**COUNCIL ACTION FORM**

**SUBJECT: REQUEST FOR DEFERRAL OF A PORTION OF THE PUBLIC  
SIDEWALK AT 712 S. 16<sup>TH</sup> STREET**

Staff has received a request to defer the construction of a portion of the public sidewalk along the frontage of the Copper Beech apartment project at 712 S. 16<sup>th</sup> Street. (See map on Attachment 1.) **The request encompasses two sidewalk segments with ramps for crossing of the site driveway. Sidewalk for the remaining full frontage of the site, including crossing of South 16<sup>th</sup> Street, will be constructed with the project.**

# Attachment 3 Sidewalk Deferral Request Map

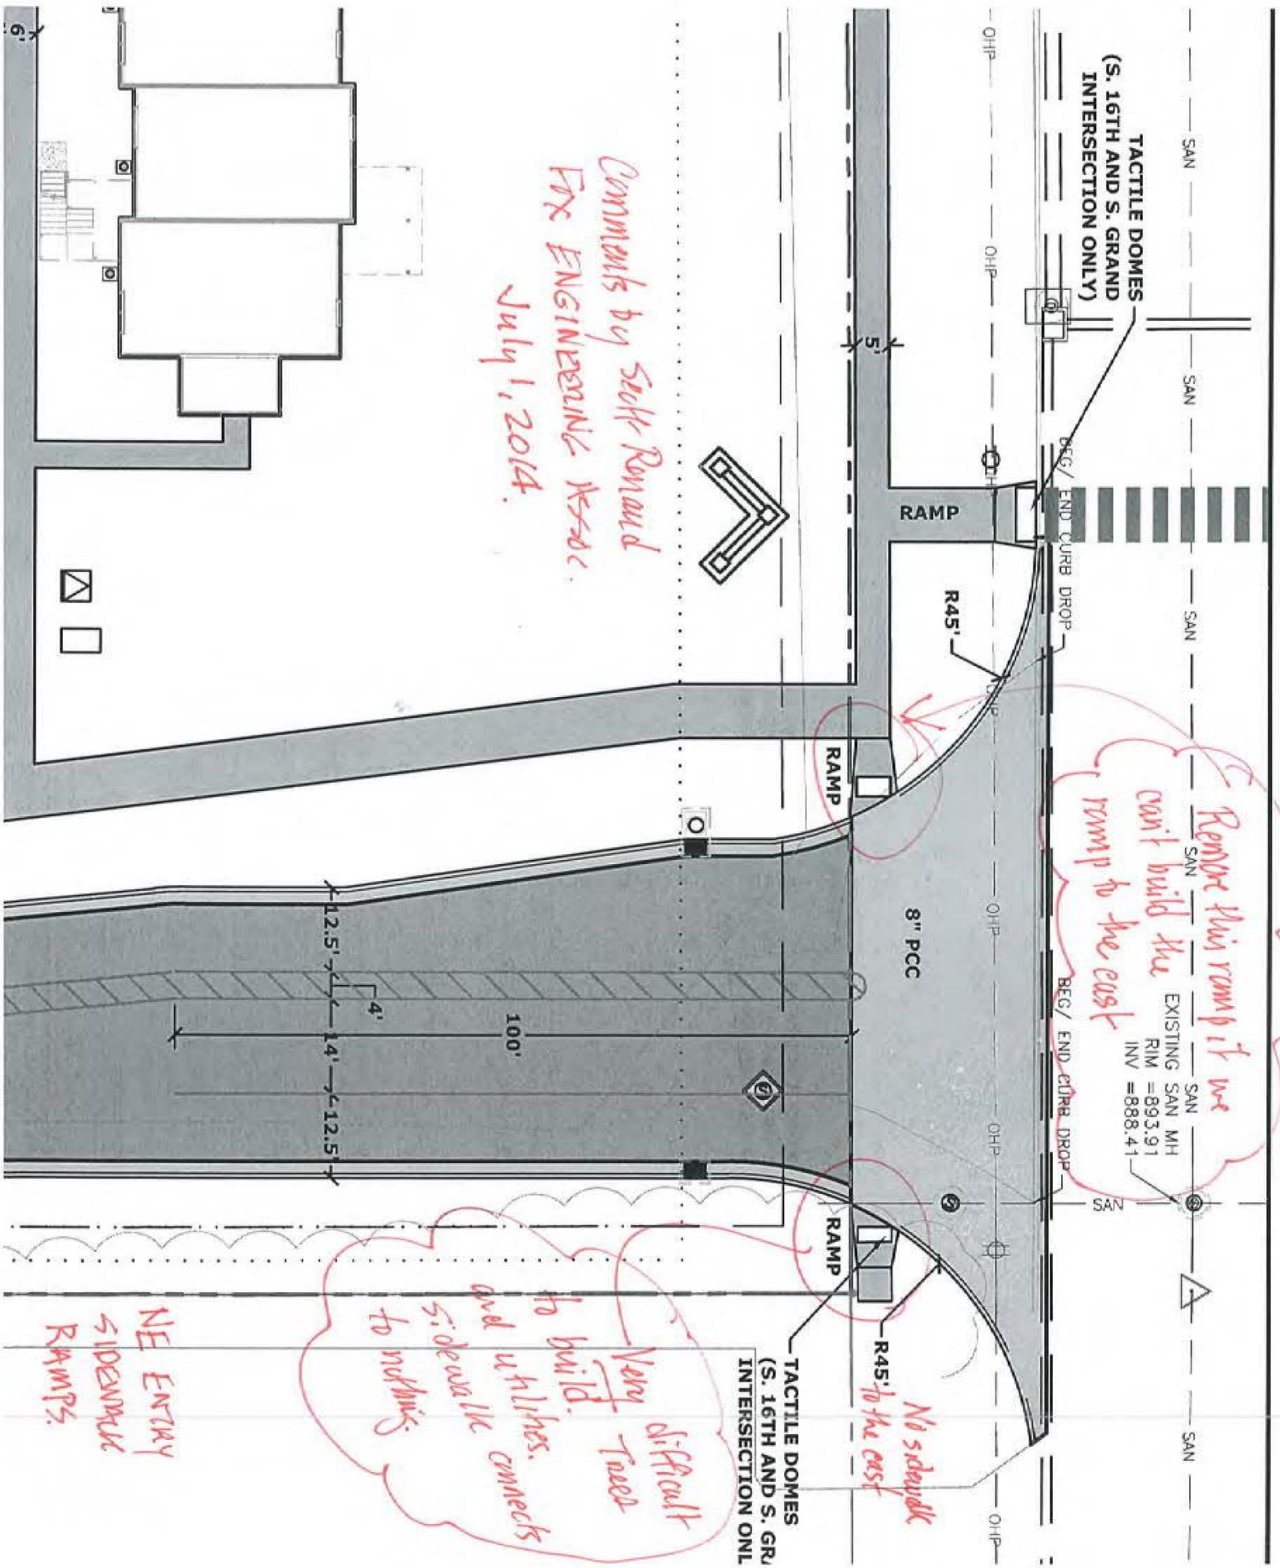
Copper Beech is a multi-family residential apartment development located between Creekside Mobile Home Park and Pheasant Run Apartments along the south side of South 16<sup>th</sup> Street. The Site Development Plan approved for the site showed a public sidewalk running the full frontage of the lot (See Attachment 2). Currently there are no public sidewalks along the south side of South 16<sup>th</sup> Street, except on the Aspen Business Park property 500 feet further east on South 16<sup>th</sup> Street. The property owner has agreed to install the public sidewalk from the west property line to the west side of the site's access drive, where a sidewalk crossing is being installed to the north side of South 16<sup>th</sup> Street for access to CyRide. The request for deferral is only for the access ramps, approximately 20 linear feet, from the west and east side of the drive to the east property line (See Attachment 3).

- 1) There is no connection to existing sidewalk abutting the subject lot to the east to make a connection with any new sidewalk.
- 2) The sidewalk access to the north side of South 16<sup>th</sup> Street is located on the west side of the driveway, so the portion of the sidewalk requested for deferral does not affect access to CyRide or pedestrian access to the site.

*Remove this ramp if we  
can't build the  
ramp to the east*

*Very difficult  
to build.  
and utilities  
connects  
to building.  
So because we  
to not have  
to not have*

*NE ENTRY  
SIDEWALK  
RAMPS.*

**The applicant has requested that the sidewalk be deferred until such time as the sidewalk is installed east of the subject site. Staff would suggest, if Council agrees to the deferral request, that the approval be conditioned that the City have authority to require installation of the sidewalk at such time as a sidewalk is extended to the east property line or if intersection improvements are made to the South 16<sup>th</sup> and South Grand Avenue intersection.**

connection is needed, that the city have the authority to require that the sidewalk connection be installed. **Therefore, it is the City Manager's recommendation that Council approve Alternative #1, thereby granting the deferral for the installation of a portion of the public sidewalk and access ramps at 712 S. 16<sup>th</sup> Street in accordance with the conditions stated above.**
